To: ALL BIDDERS
Ref: NEW RIVER C & TC – GREENBRIER HALL ROOF RENOVATION
Subj.: ADDENDUM BULLETIN NO. 4

1. A-5.2: REPLACE sheet in its entirety, see Enclosures. Updated have been clouded and tagged. Revisions relate to roof details.

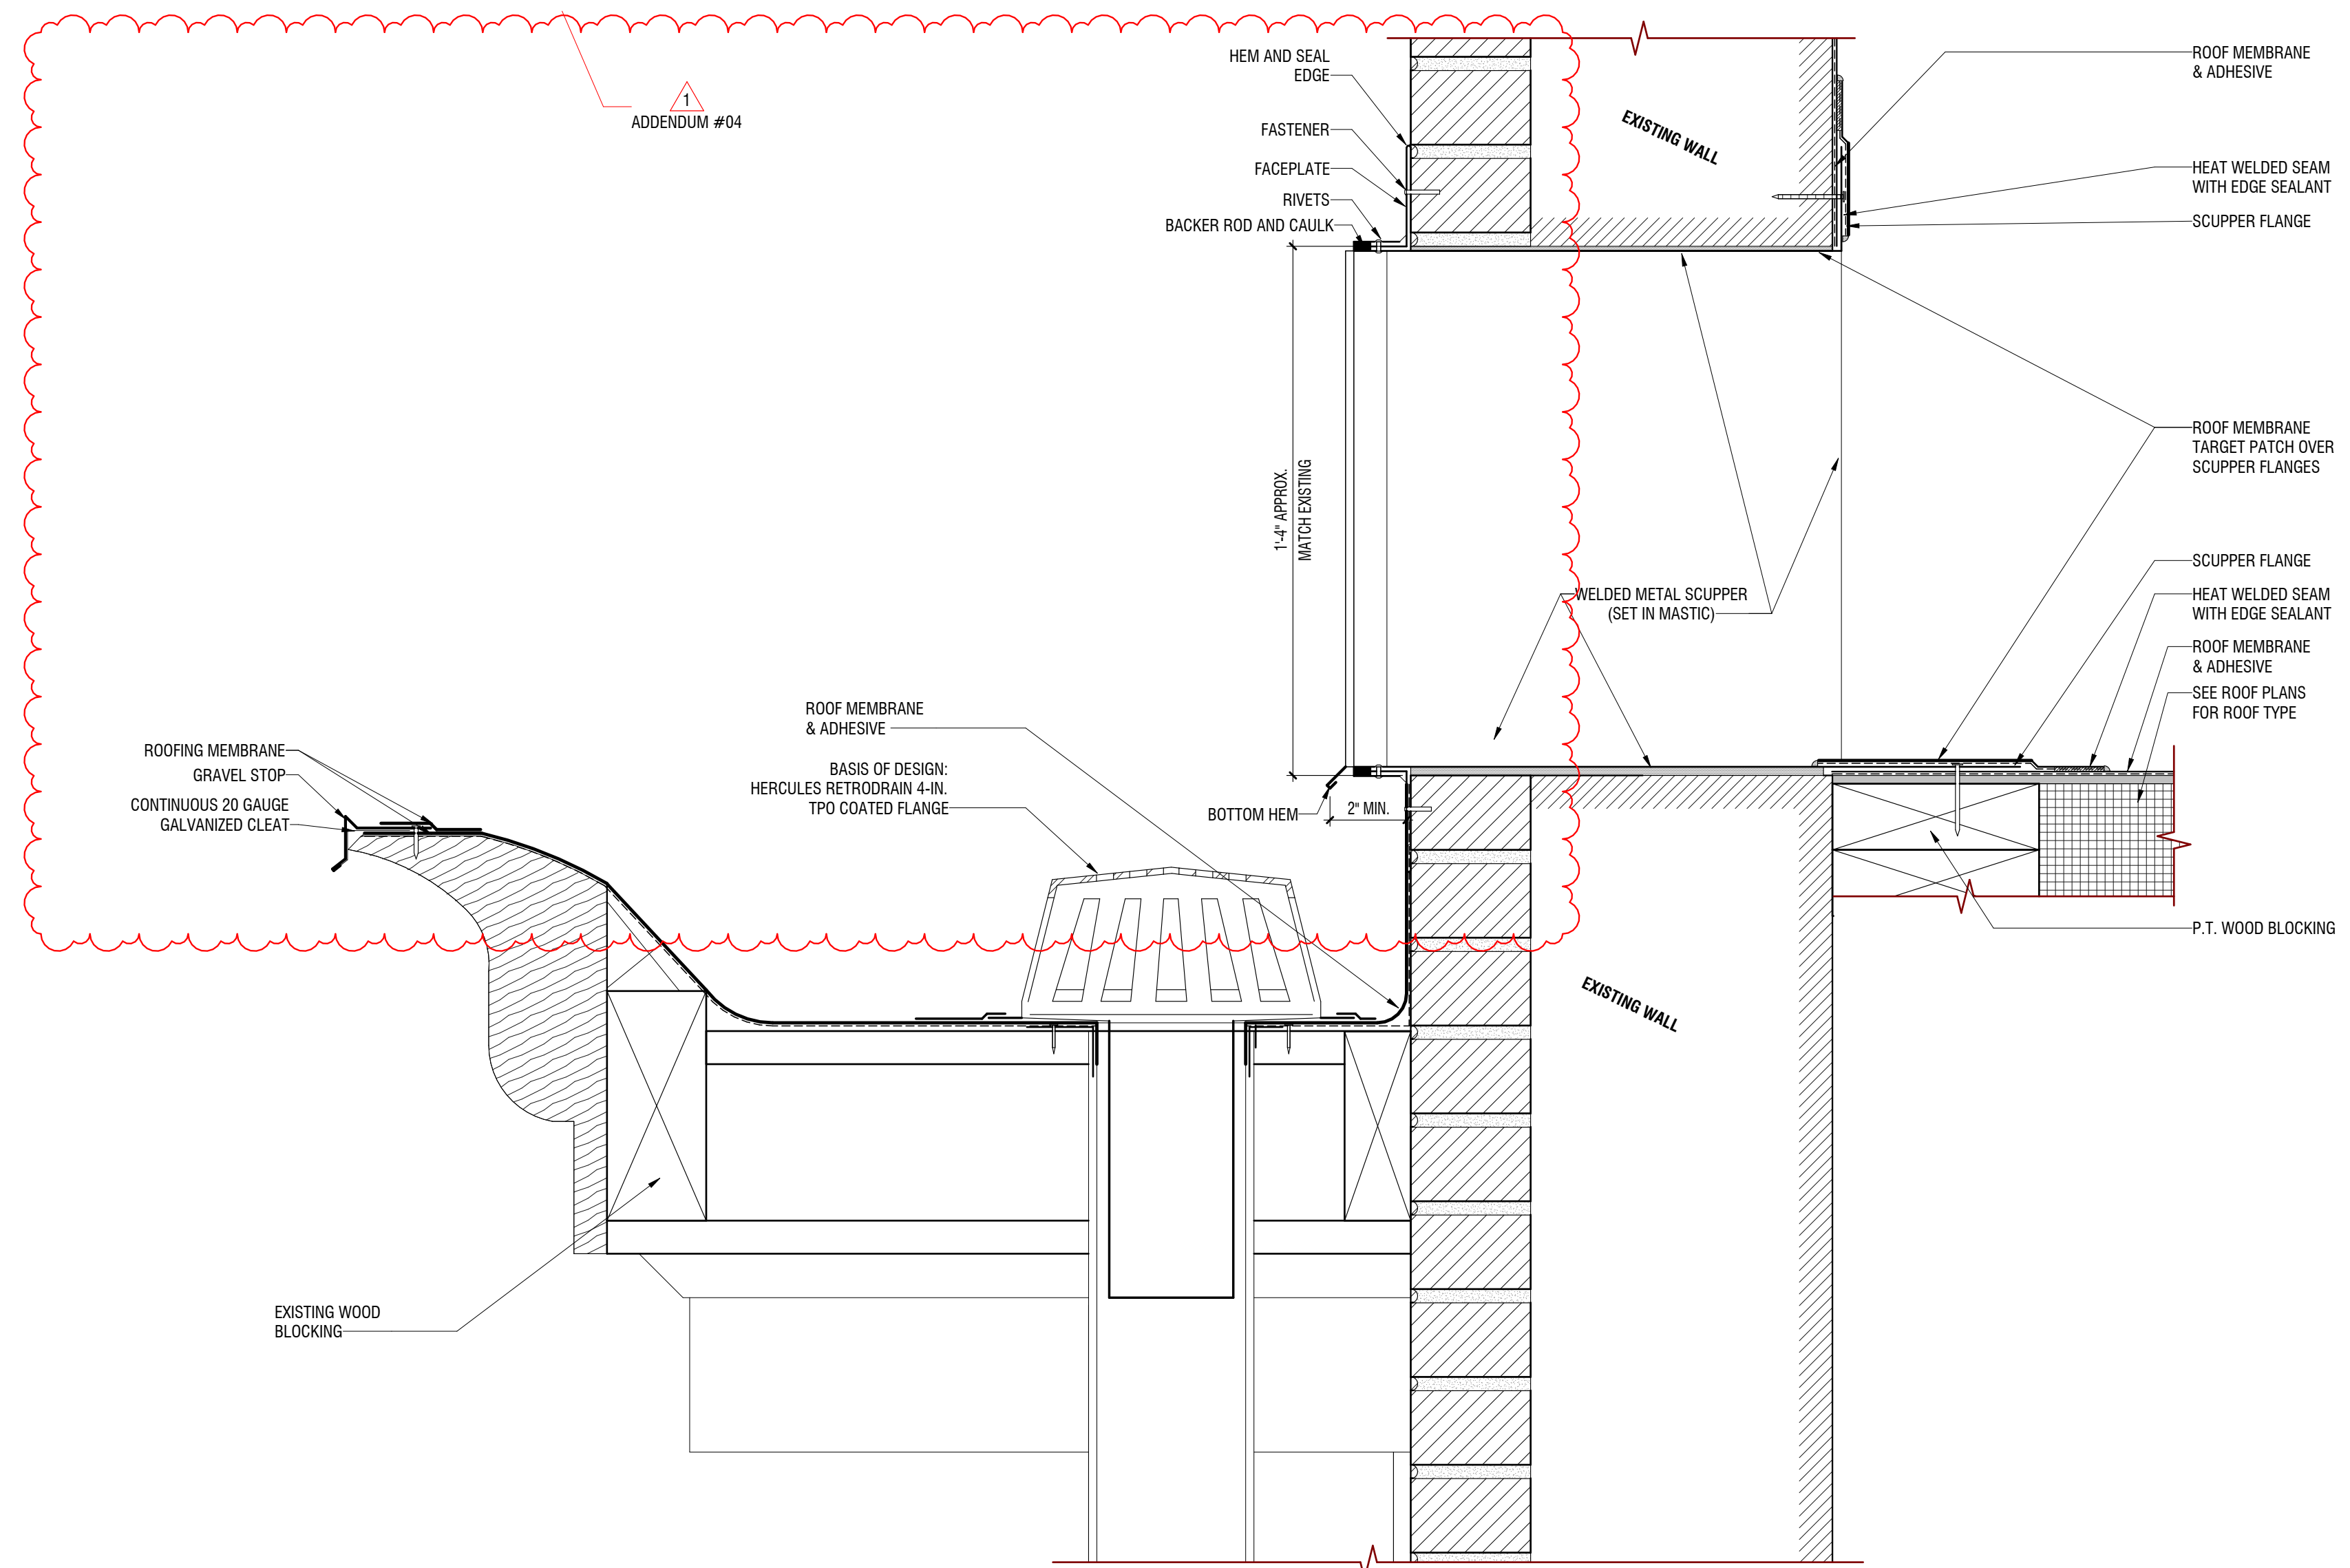
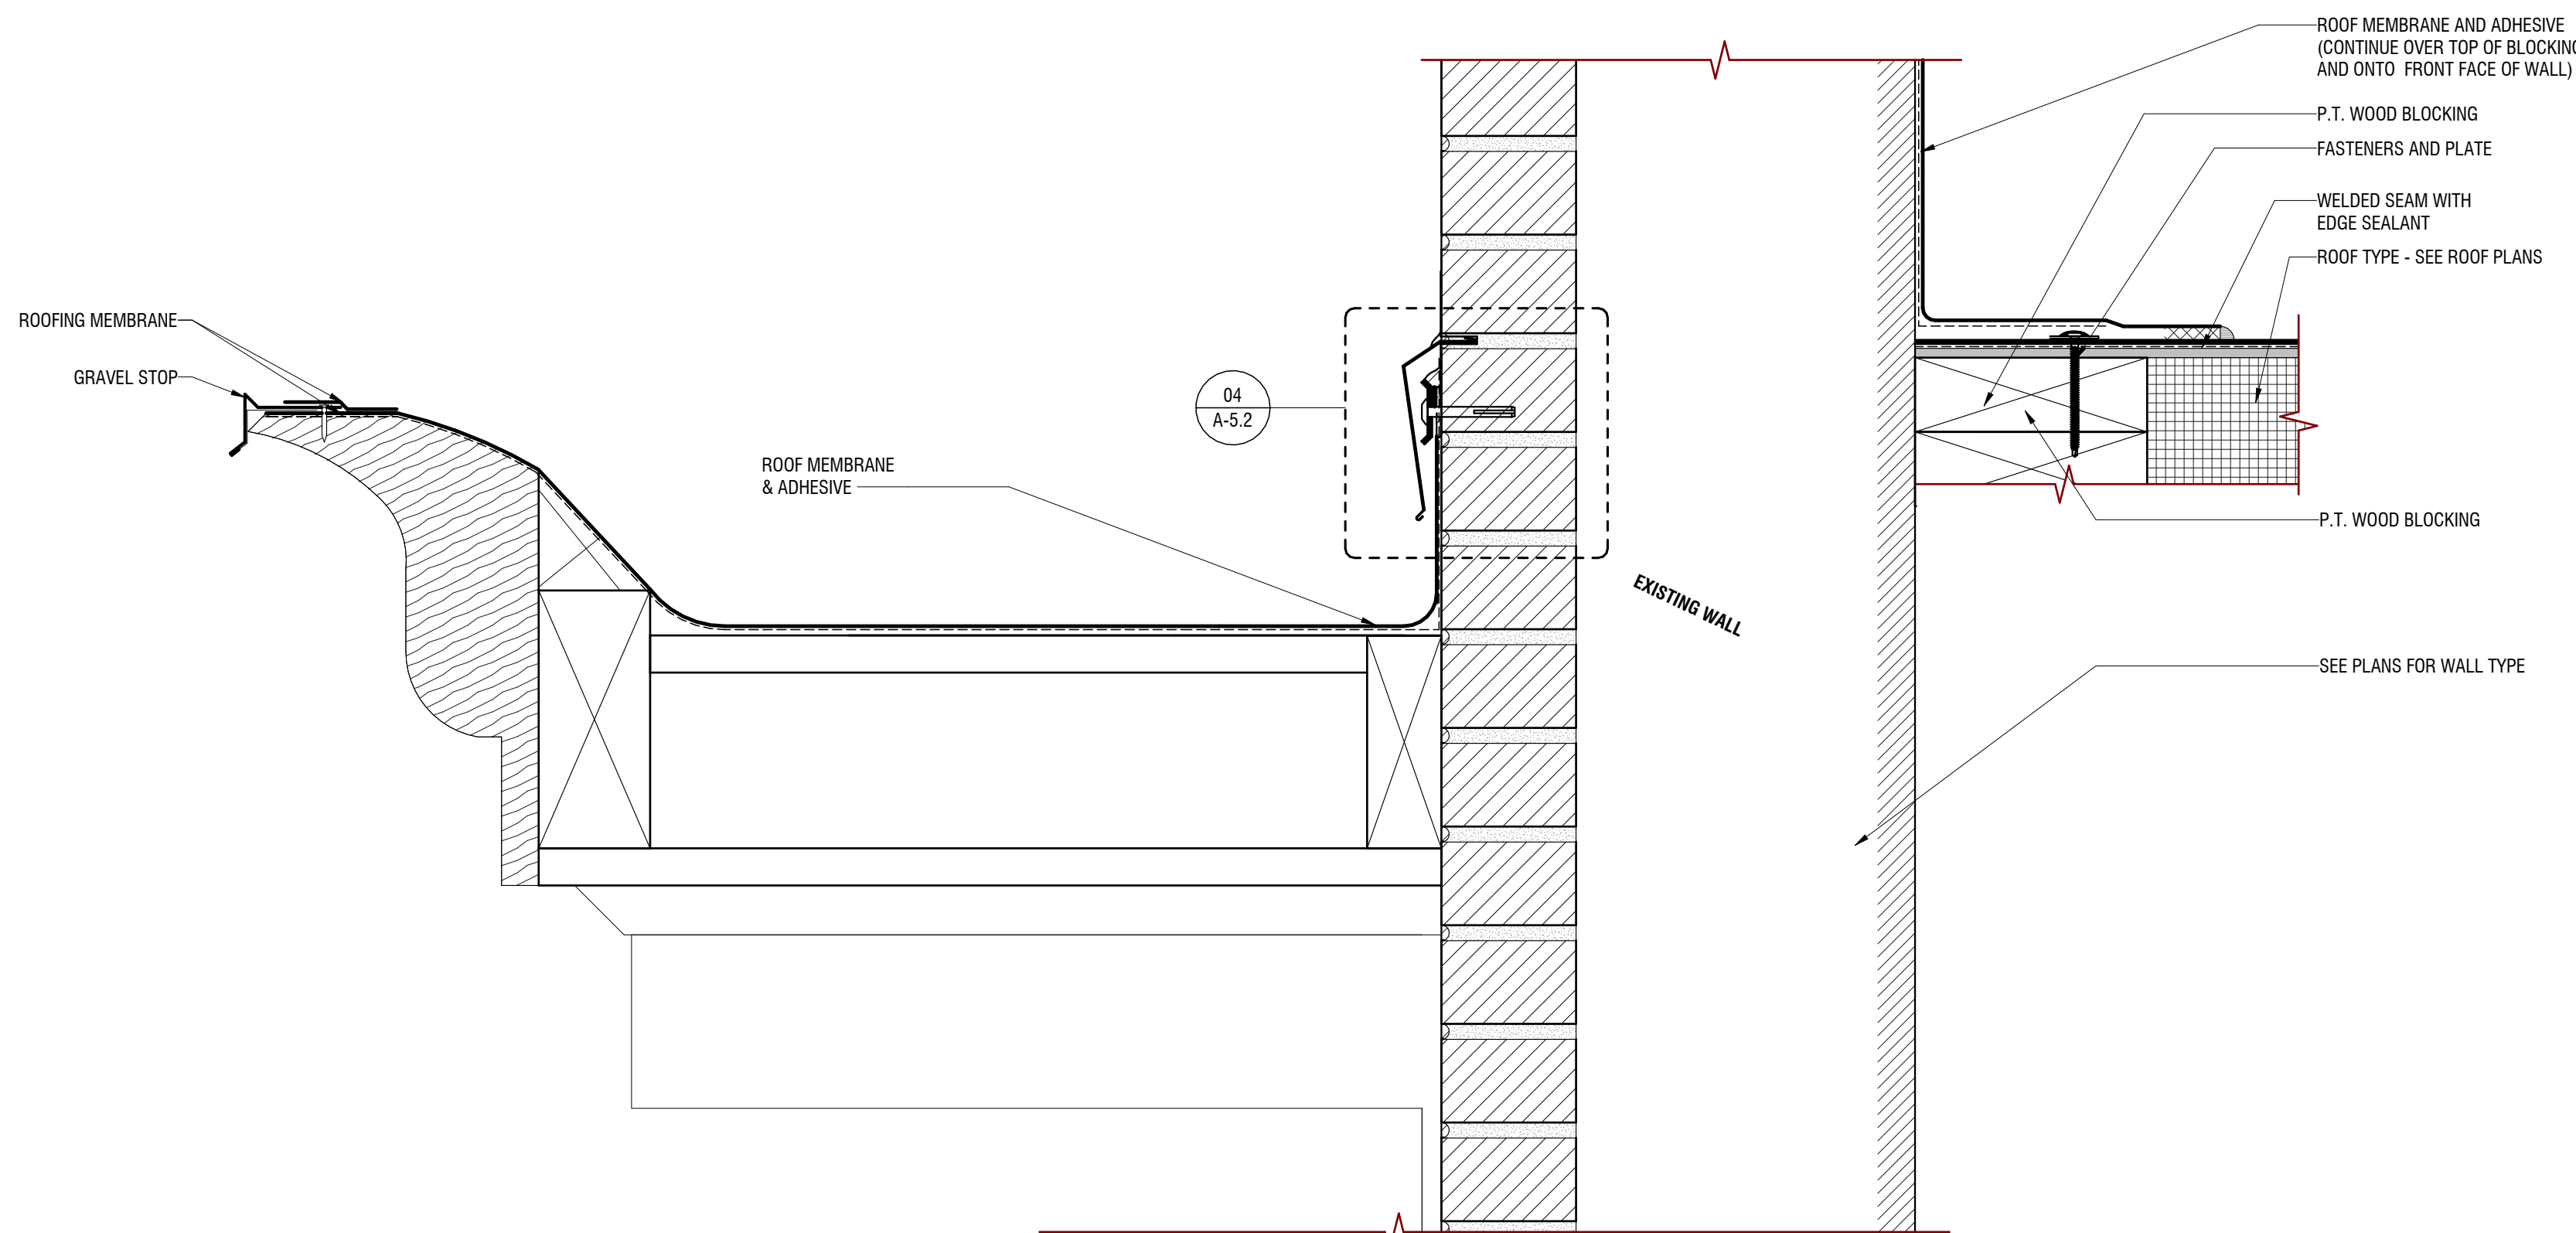
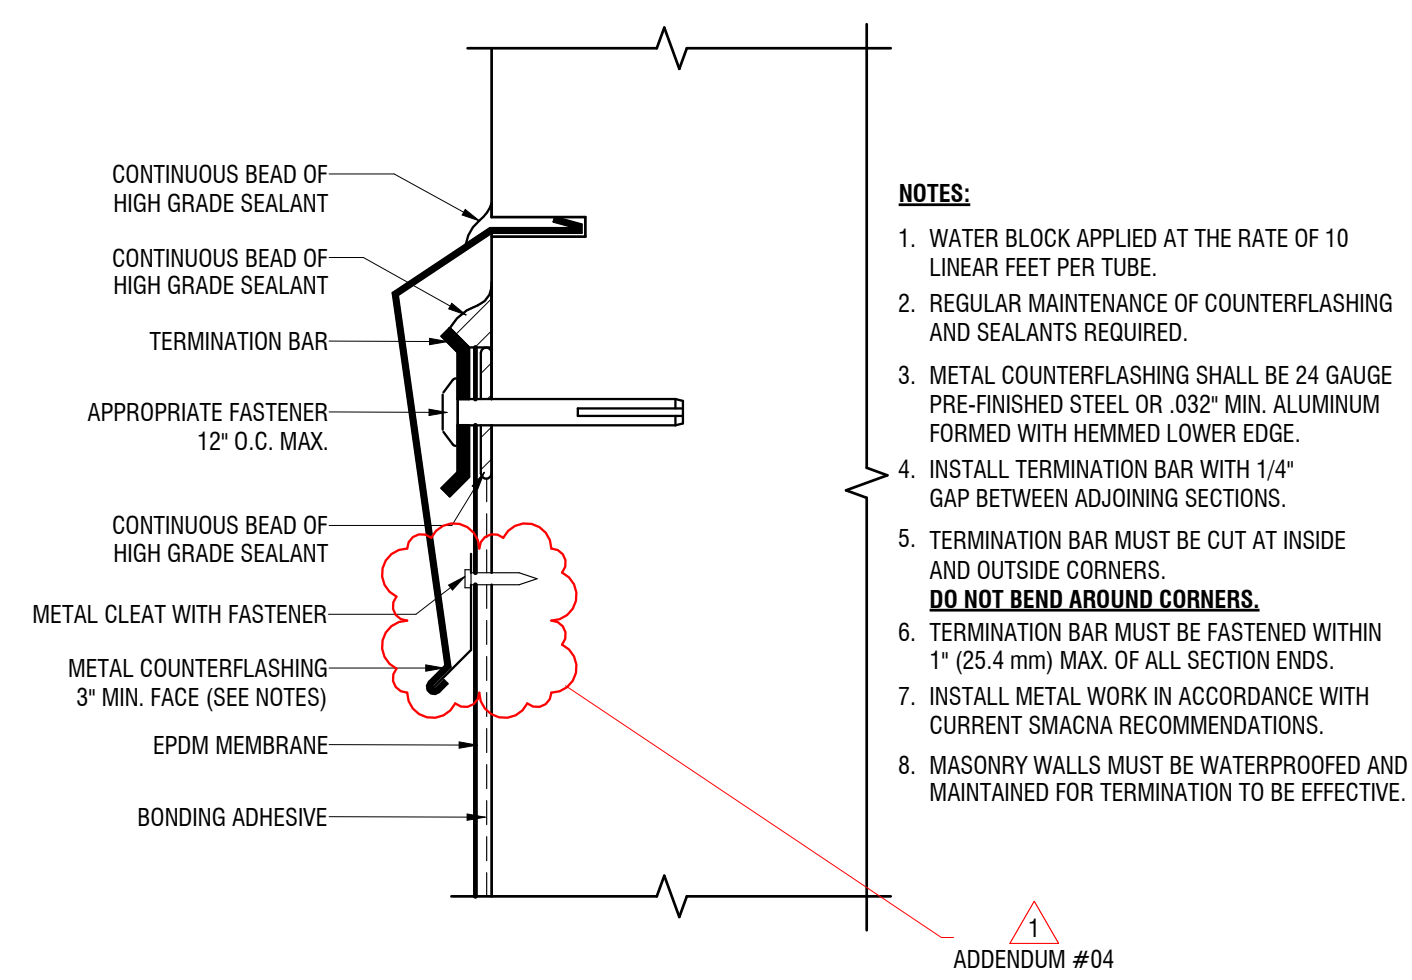
- a. Porch roofs to receive FlashCo's TPO FlashDrain Drain Boots as Basis of Design, comparable products may be used upon approval by Architect.
- b. Cornice gutter to receive Hercules RetroDrain TPO Coated Flange 4" as Basis of Design at all downspout locations, comparable products may be used upon approval by Architect.
